PROPOSED RESIDENTIAL DEVELOPMENT THE RESIDENCES AT 95 BREWSTER STREET PORTSMOUTH, NEW HAMPSHIRE PERMIT PLANS

RE: Request for Site Plan Approval at 49 Sudbury Street & 95 Brewster Street, Tax Map 138 / Lots 57 & 58

1) Prior to submission to Planning Board, plans shall be updated to address the following:

DEMOLITION PLAN **C2**

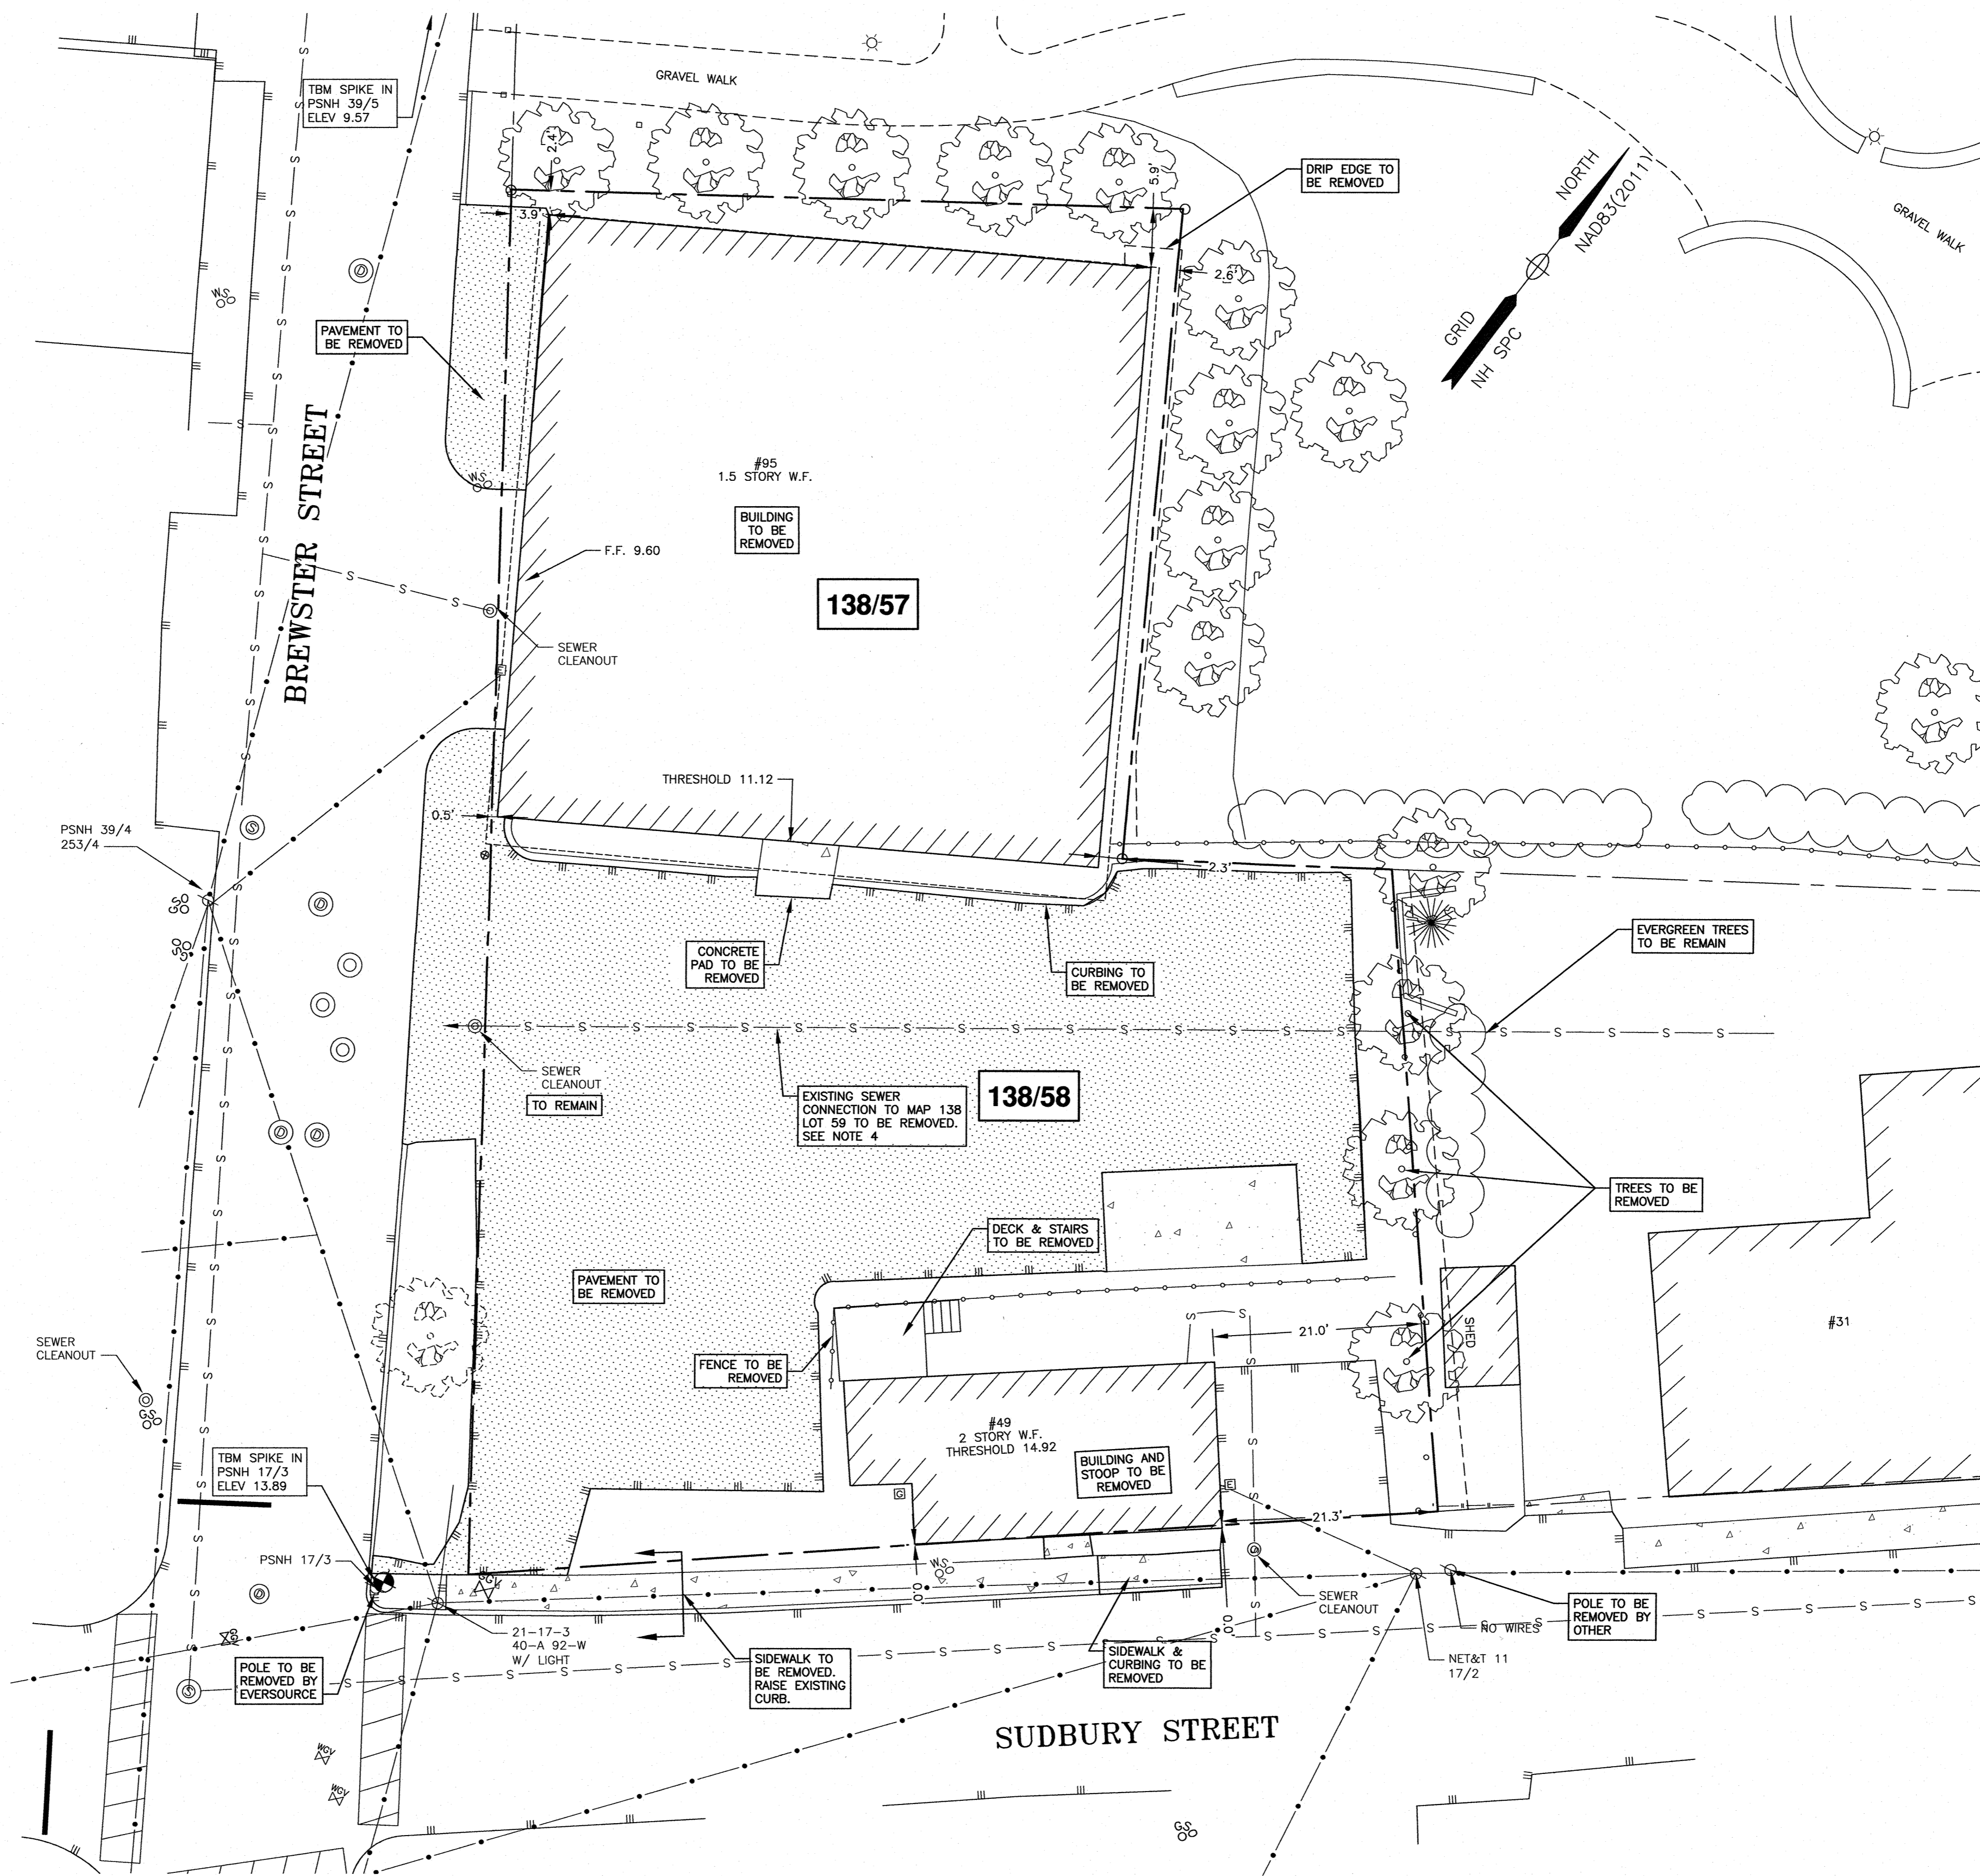
- e) Show the existing sewer heading to #31 Sudbury to be removed on the demolition plan; **This has been noted - see Sheet C2.**
- f) There are two water services shown going into the existing warehouse building. The one shown nearest the sewer does not exist. Please remove from plan; **This has been done - see Sheet C1.**

SITE LAYOUT PLAN

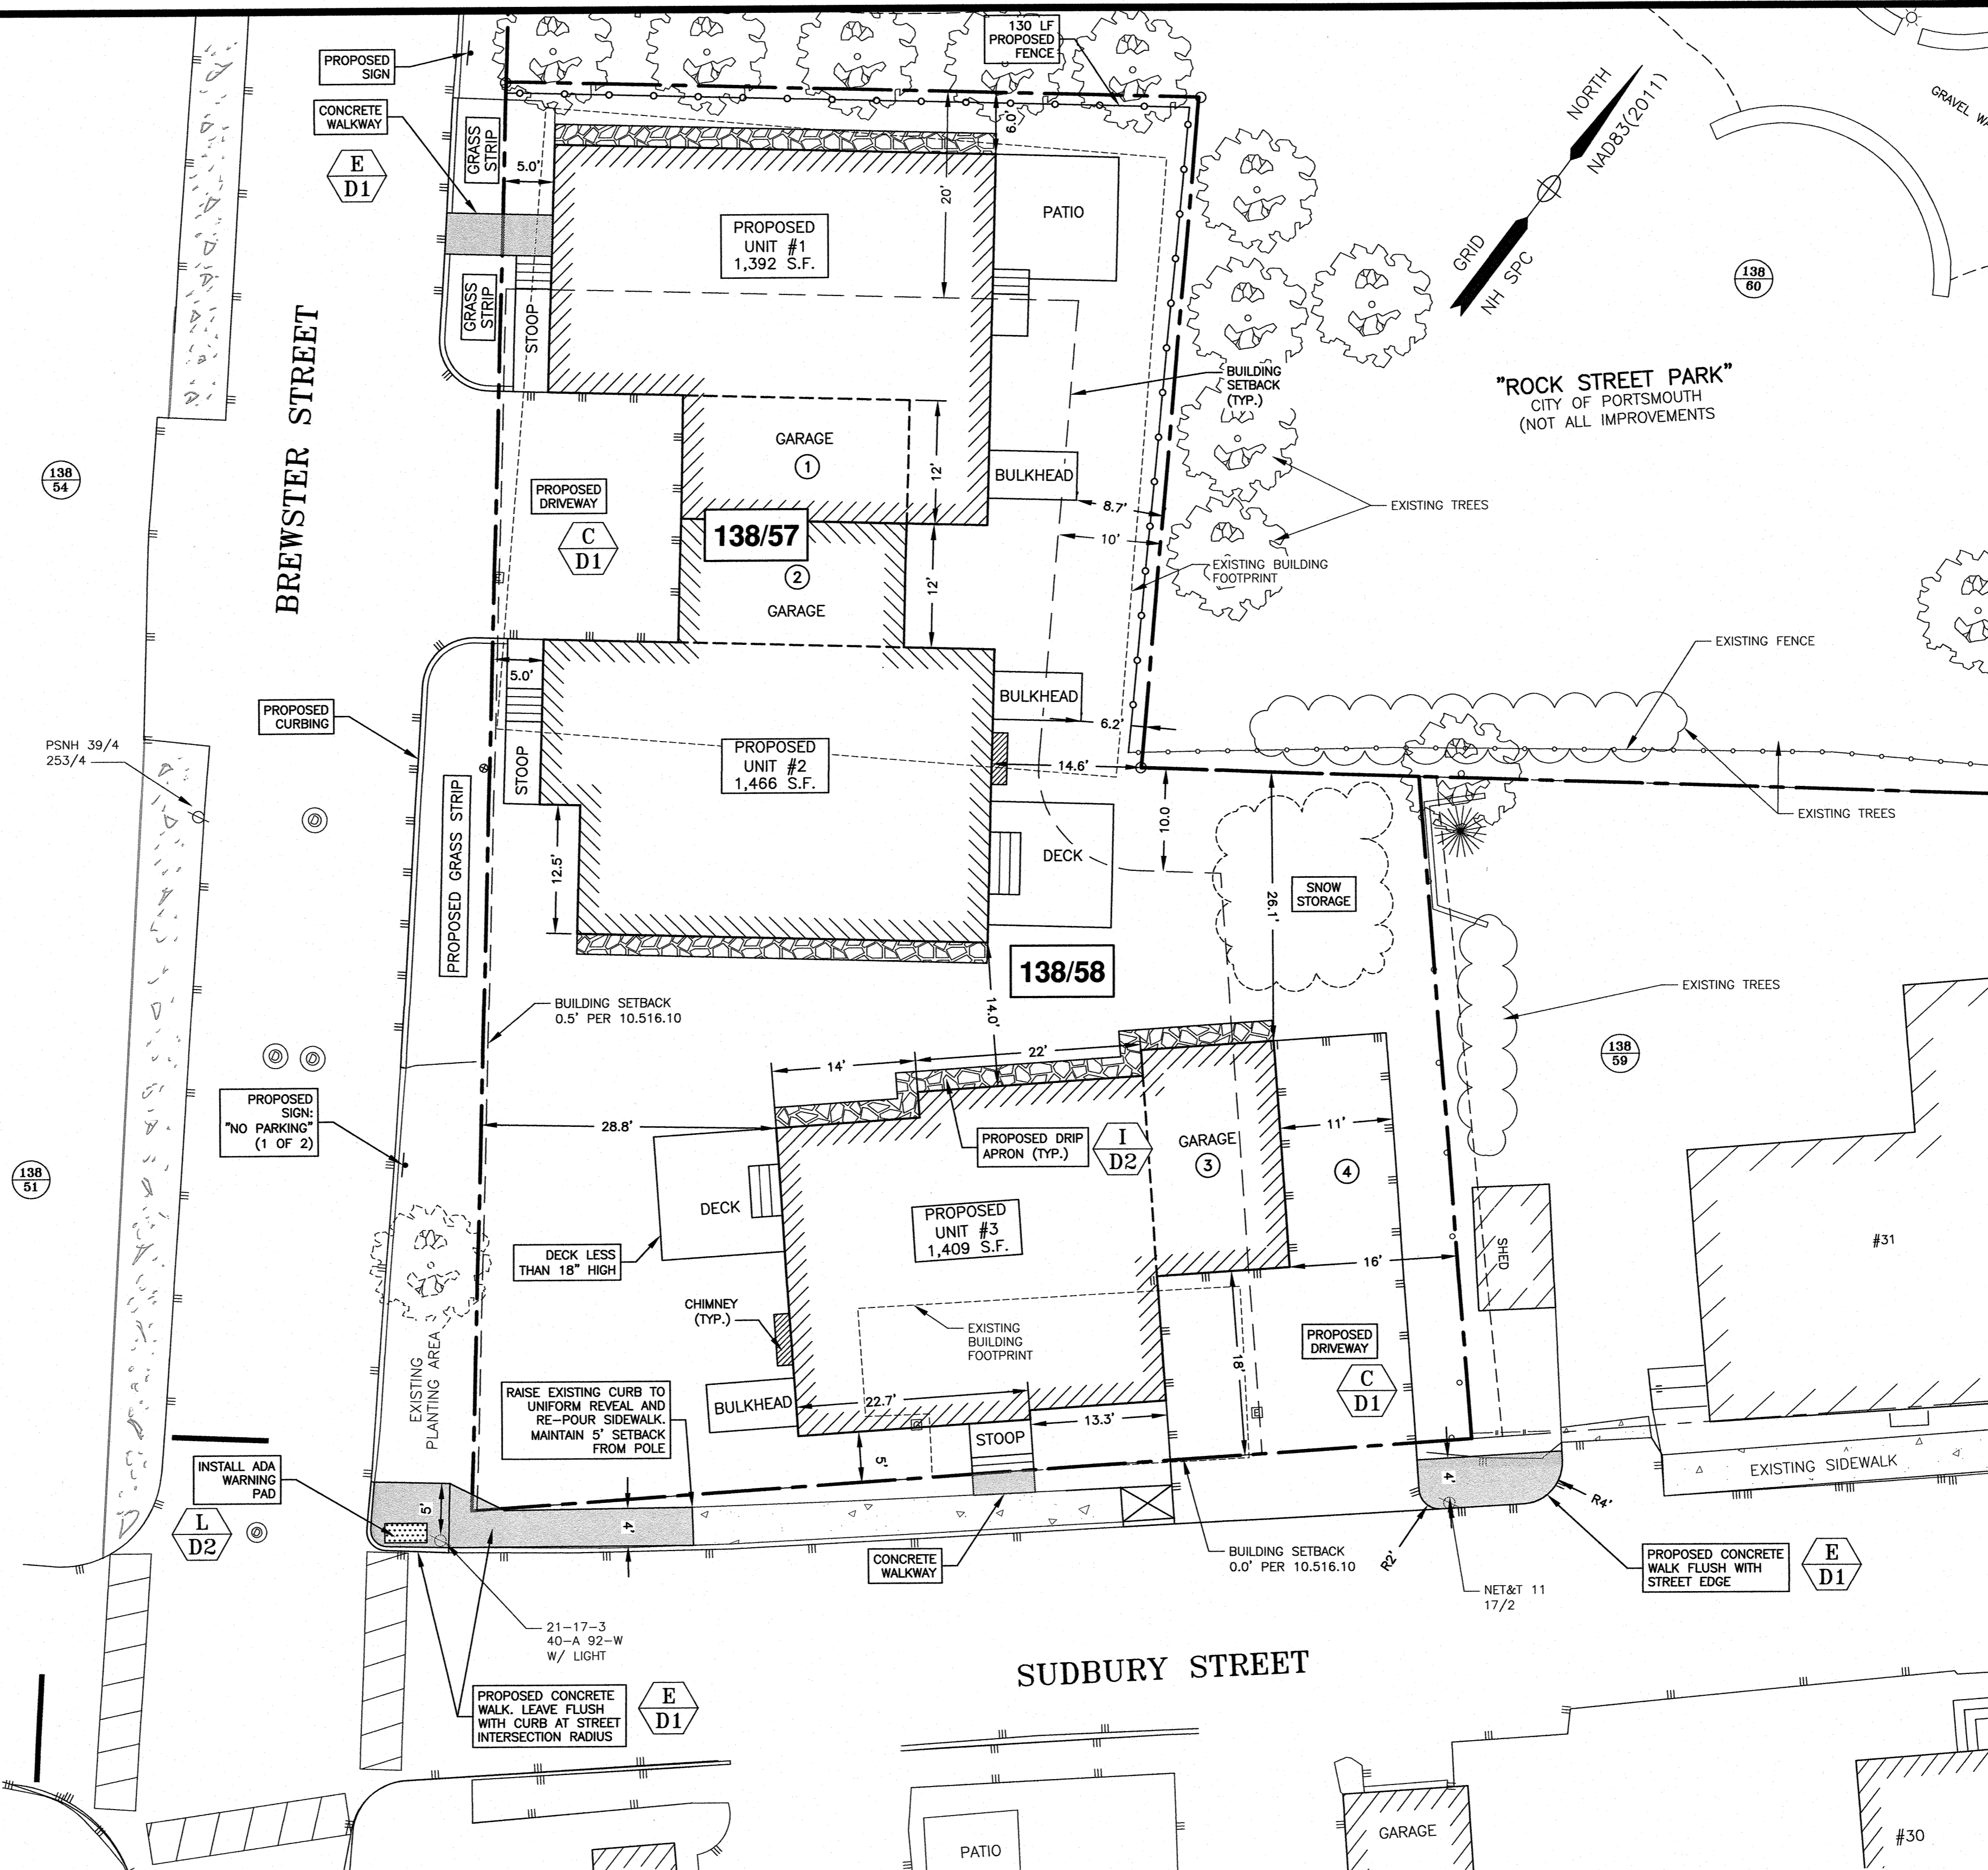
- a) There is not enough clearance on the pole at the corner of Sudbury and Brewster to run conduit up the pole. Sidewalk will need to be widened to accommodate this design; **The sidewalk has been widened – see Sheet C3.**

- b) An ADA accessible ramp shall be added to the sidewalk at the Brewster Street / Sudbury Street intersection; **The ramp / tactile warning strip has been added - see Sheet C3 and Detail L.**

- i) Add note that the City will require street milling and paving in areas damaged by utilities or construction; **The Note has been added as Note 9 on Sheet C3 and as Note 7 on Sheet C5.**

- j) Add note that all invasive species to be removed in accordance with best management practices; **The note has been added as Note 10 on Sheet C3.**

- k) There is a section of curb with very low reveal near the intersection of Brewster Street and Sudbury Street. This section should be reset to match the reveal of the rest of the sidewalk, so that it is not used as a driveway to the parcel; **The area of sidewalk replacement and curb revision has been shown - see Sheet C3.**

- l) Install NO PARKING signs along Brewster Street frontage; **These have been added to the plans - see Sheet C3.**
- m) The sidewalk should be constructed to the east of the driveway on Sudbury Street and include the area in front of the abutting shed; **The plans have been revised to show a flush sidewalk section in this location - see Sheet C3.**

- n) The width of the driveway should be narrowed on the Sudbury Street house to 24 ft; **The driveway width has been narrowed - see Sheet C3.**
- o) The language found in the Landscaping notes should be consistent with the tree planting detail notes (e.g. planting note 4 calls for all burlap and cages to be pulled open in planting hole--not removed--, while tree planting detail calls for all cage and burlap to be removed); **The notes have been revised - see Sheet C6.**

2) Coordinate addressing of proposed units with the Fire Department and DPW. **The Note has been added as Note 11 - see Sheet C3.**
